Presentation #2 – Site + Building Form

RiverHouse

Rezoning (REZN22-00007)

Phased Development Site Plan (SPLN23-00001)

Green Ribbon (Primary Route)

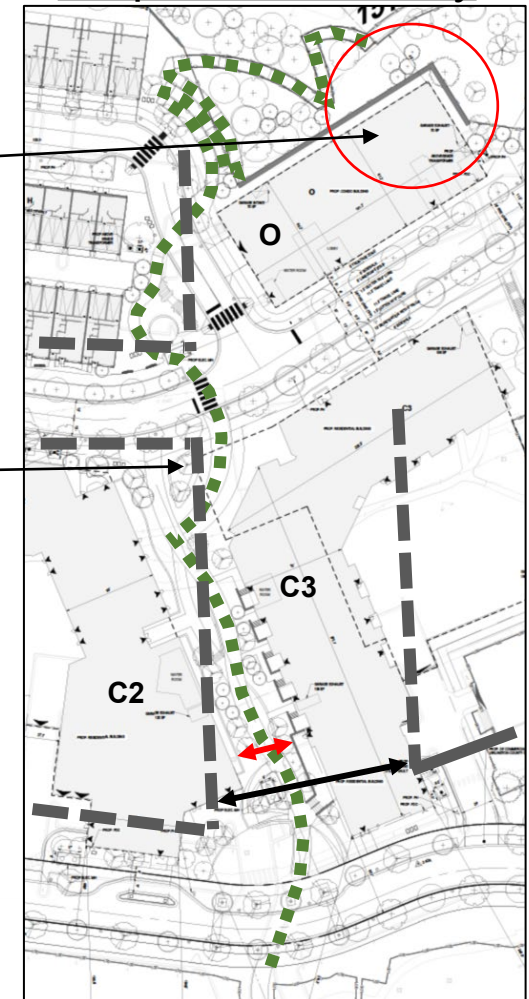
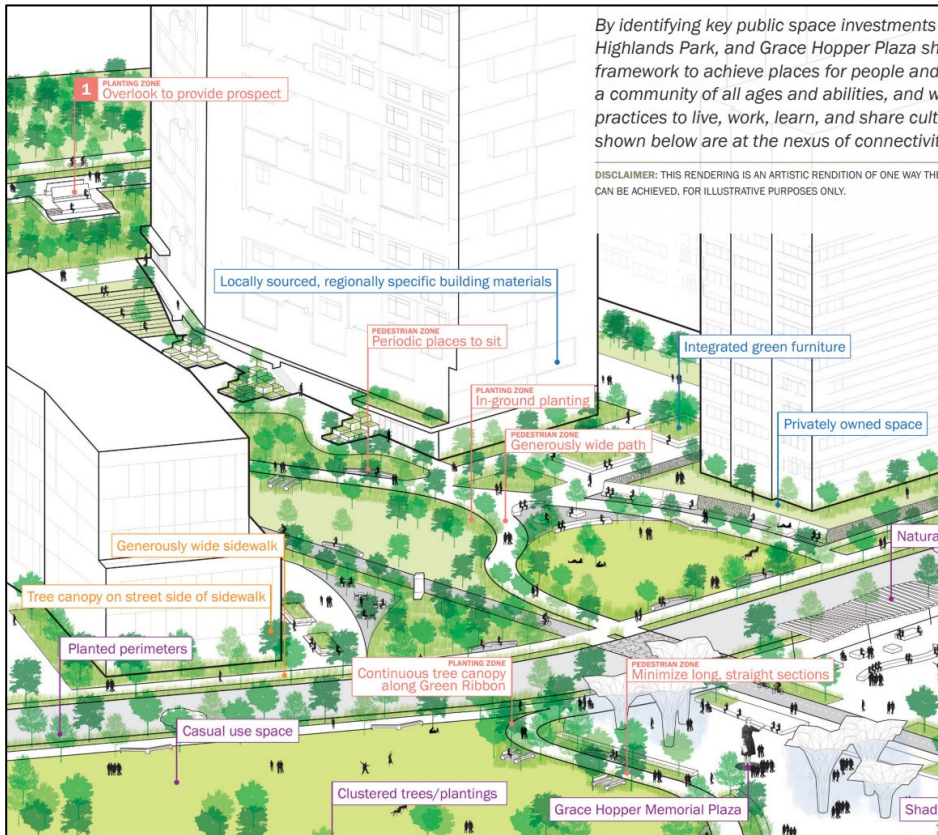
Building footprints encroach into public space

- Width reduced by 50%** between C2 and C3 ↔
- Circuitous, fragmented routing** around buildings
- Potential planting area lost

- Build-to zone max. = 12 ft

Green Ribbon (Primary Route)

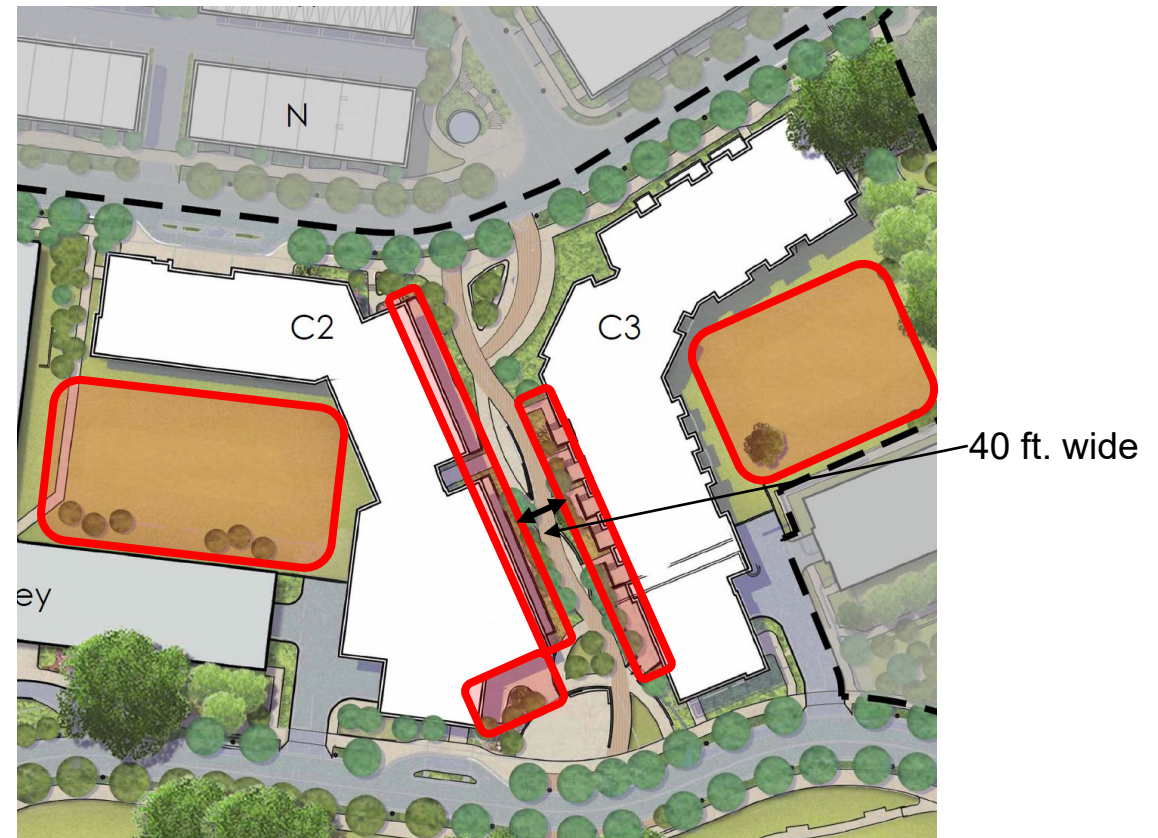
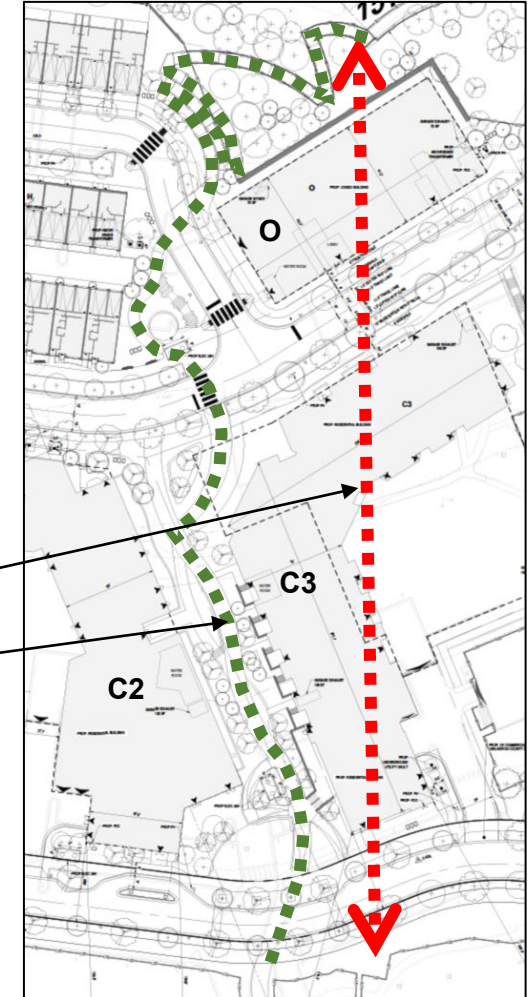
Line of Sight Obstructed by Buildings

proposed building placement **contradicts PCSP recommendations** for clear visual and physical connection, making it overly difficult to navigate between 15th Street and Virginia Highlands Park

“The most important design element of the Green Ribbon across all sites is the **quality and continuity** of the connection—ensuring sightlines, the pathway, and the experience are **continuous, easy to navigate, and visible**”

N1/N2 Buildings

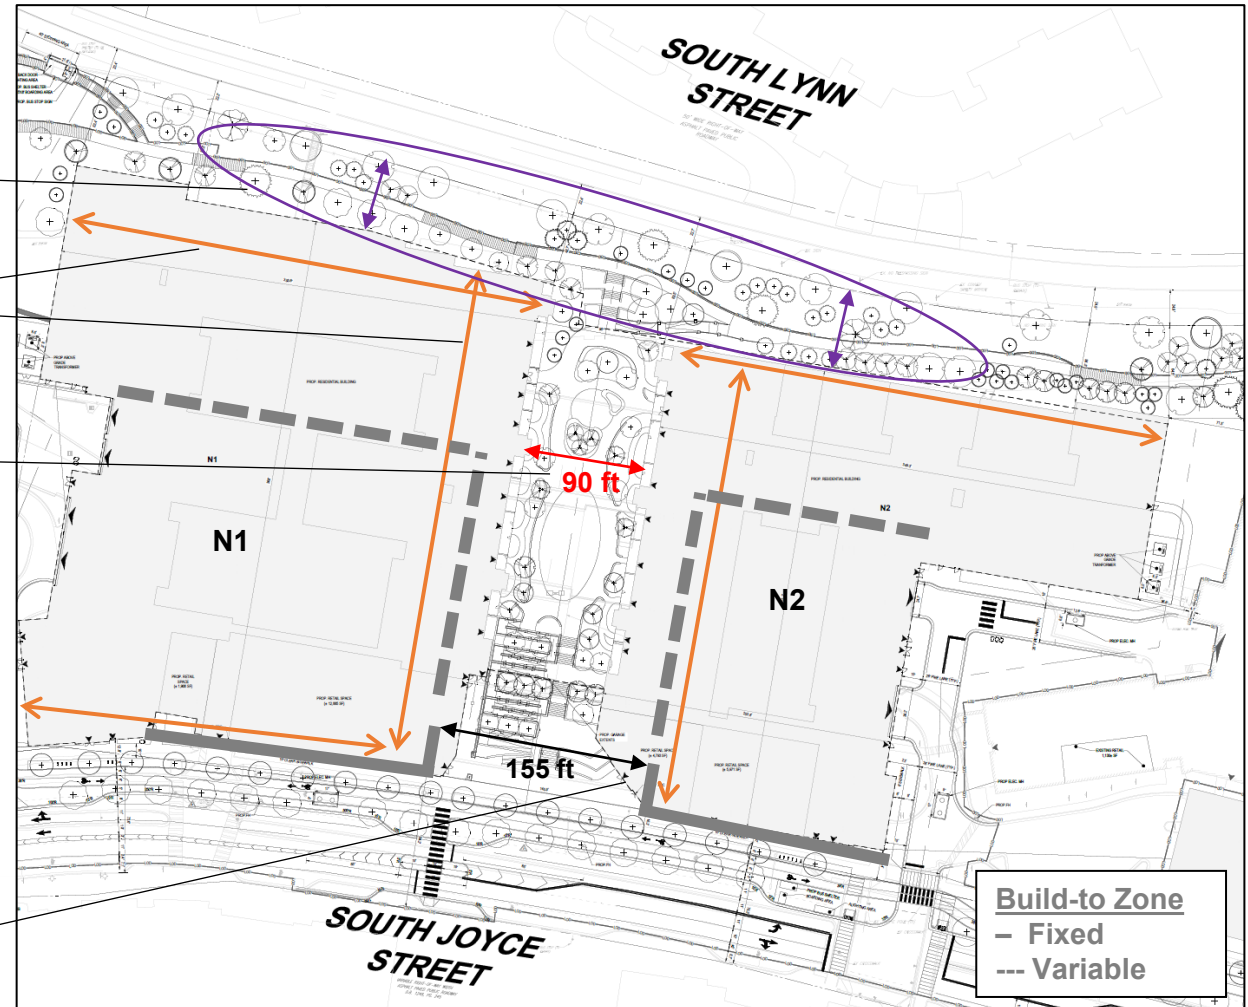
Excessive lengths/footprints; constrained public space

60-ft. canopy zone not maintained; Green Ribbon pushed west; missing casual use space

Façade lengths greatly exceed max.

Narrow plaza width

PCSP	Proposal
Park/plaza space width	155 ft (+/-12 ft)	90 ft
Façade lengths	≤ 250 ft	>300 ft
Tree canopy/forested zone	60 ft	<60 ft

N1/N2 Buildings

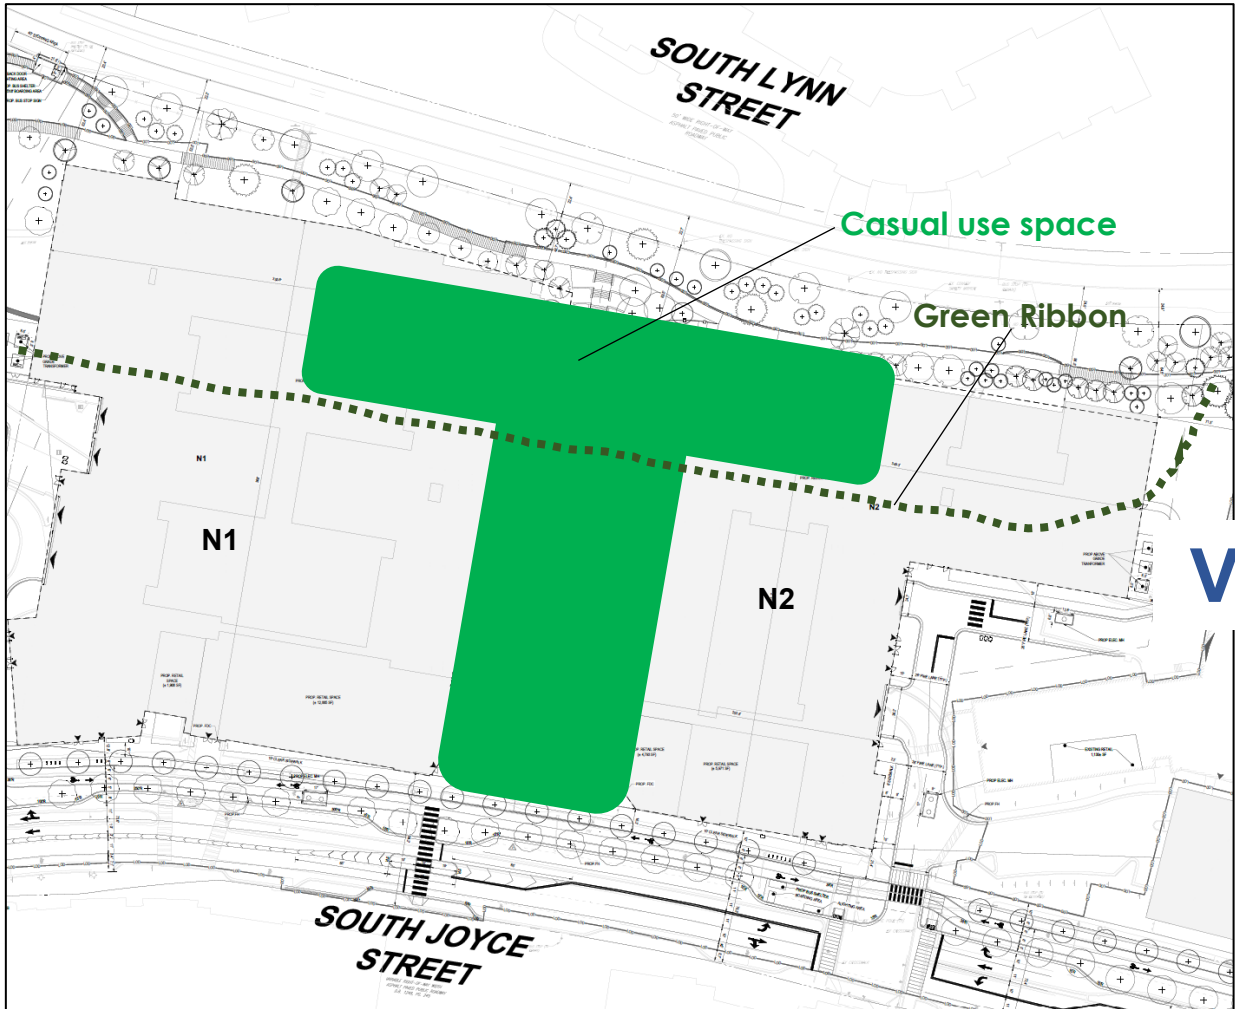
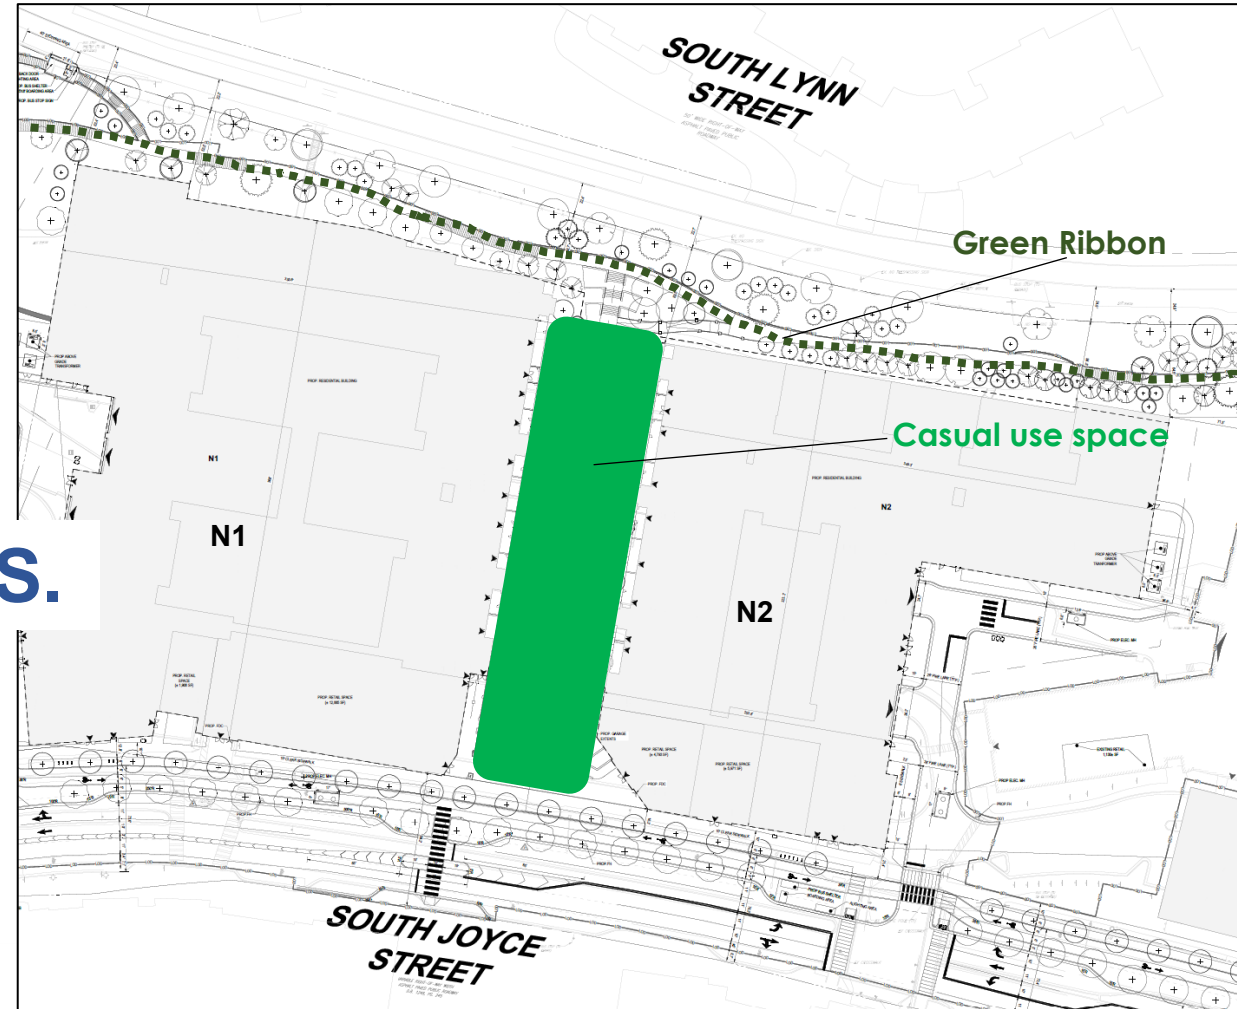
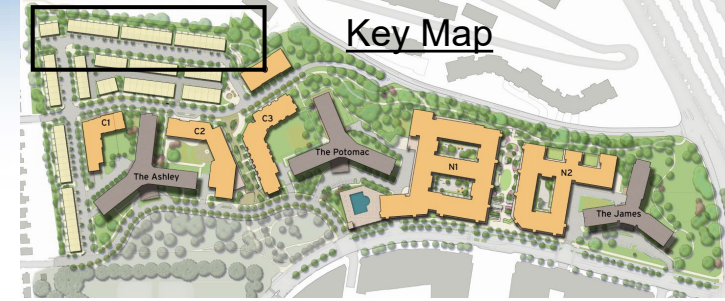
Building corners over Fixed Build-to Zone

Excessive lengths/footprints; constrained public space

- Buildings encroach into potential forested/public space along the western lot line
- No casual use space provided west of N1/N2 buildings
- Counting Green Ribbon acreage towards park space vs. providing two distinct spaces
- Building corners on Joyce Street exceed Fixed Build-to Zone; lack recommended alignment with Westpost plaza
- Narrower destination public plaza space between the N1 and N2 buildings

Land Bay S: Western Lot Line

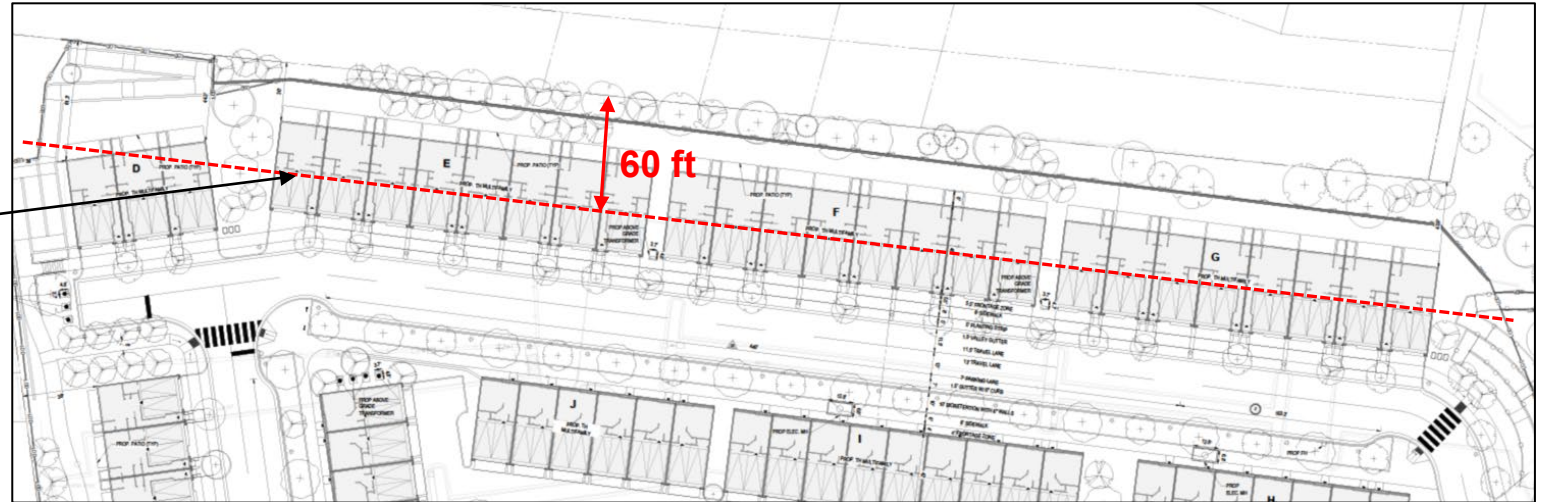
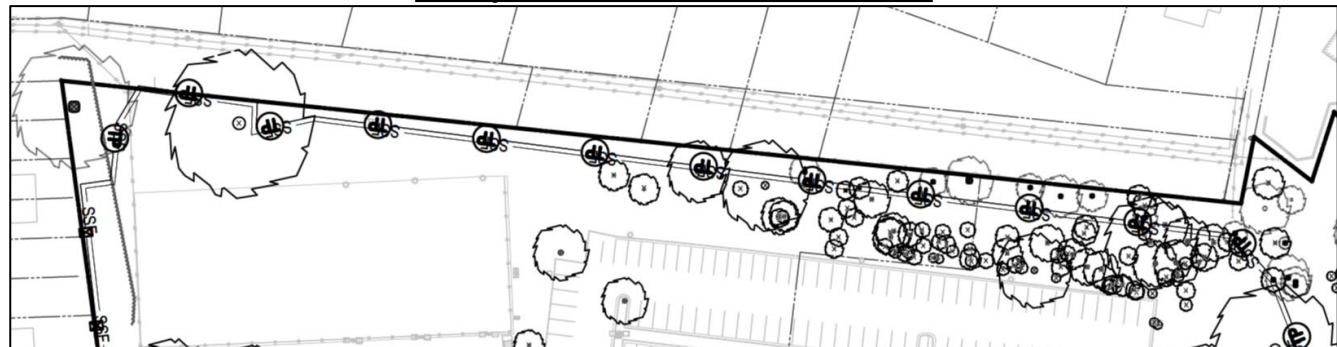
Buildings Encroach into Tree Canopy Area

- Proposed townhouses encroach into canopy zone; ~30 ft vs. 60 ft setback from lot line
- Lost opportunity for maintaining/adding trees

- PCSP: recommends 60 ft. canopy area for trees/plantings

Land Bay S: Southern Lot Line

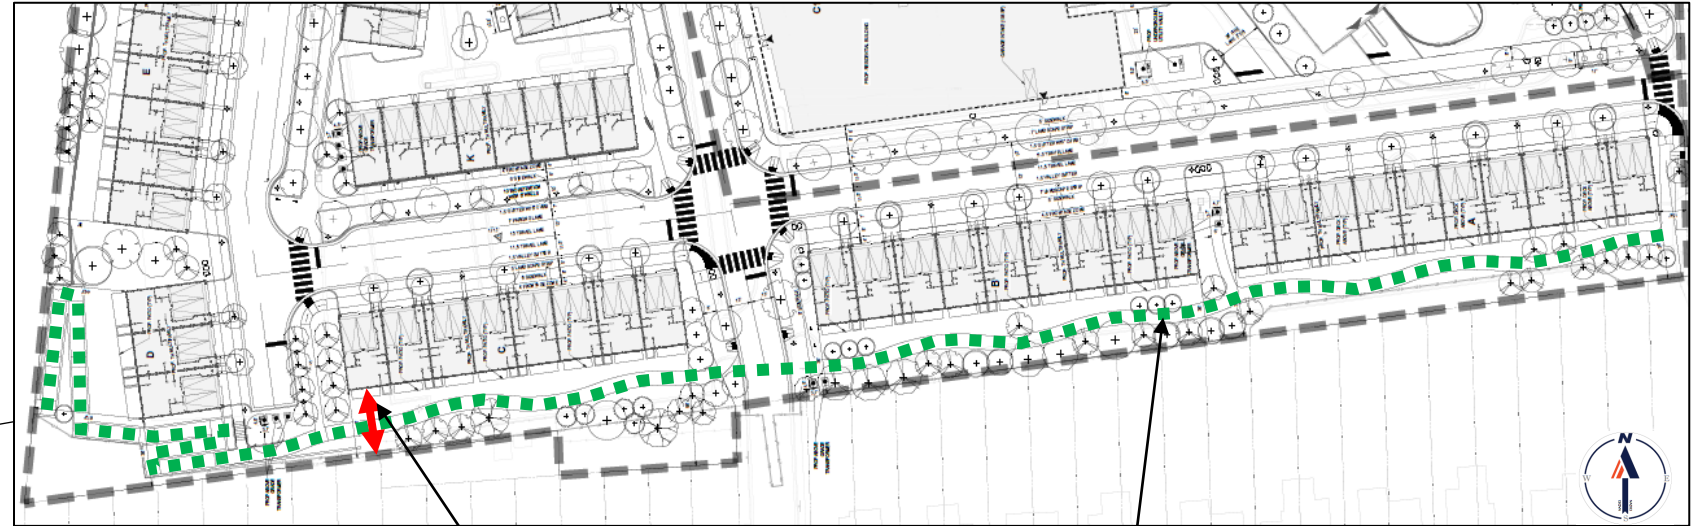
Townhouse decks marginally encroach into tree canopy area / 40 ft. setback

Green Ribbon placement south vs. north of Build-to Zone

N1 Building: Amenity Wing

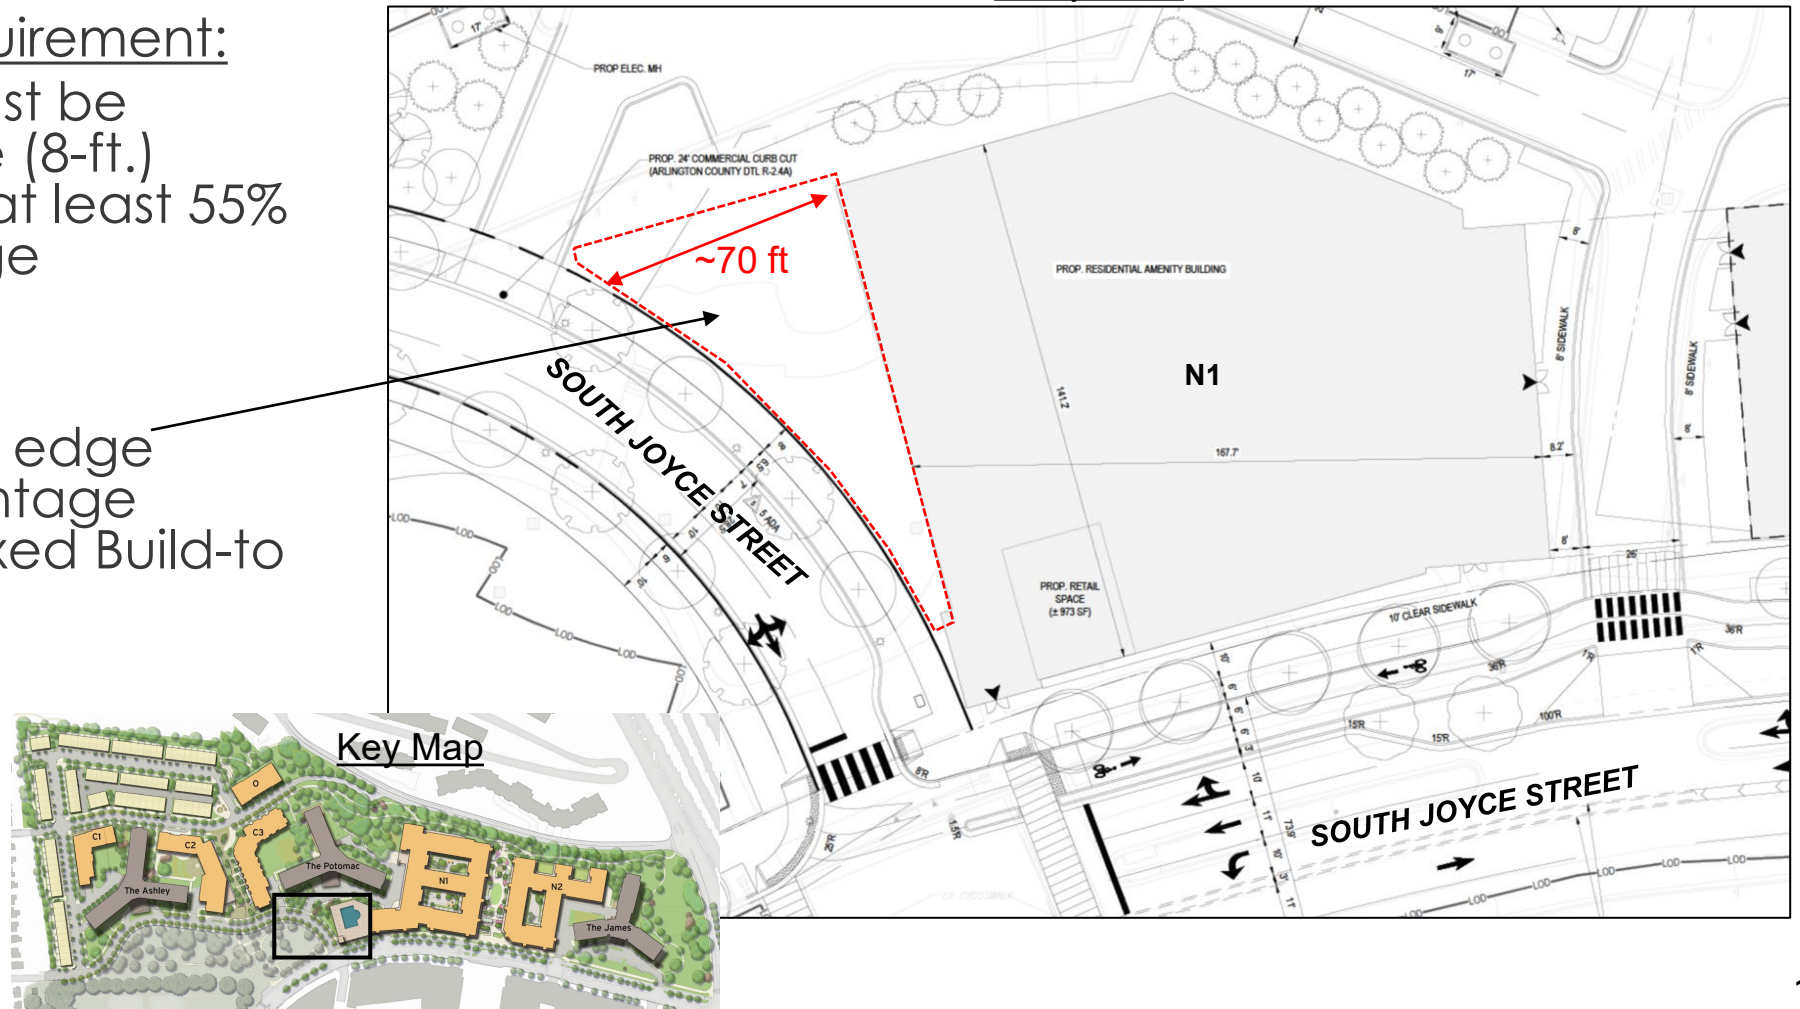
Building edge does not engage S. Joyce Street sidewalk

- Southern building edge doesn't meet frontage requirement or Fixed Build-to Line

- Building edge must be present within the (8-ft.) build-to zone for at least 55% of the parcel edge
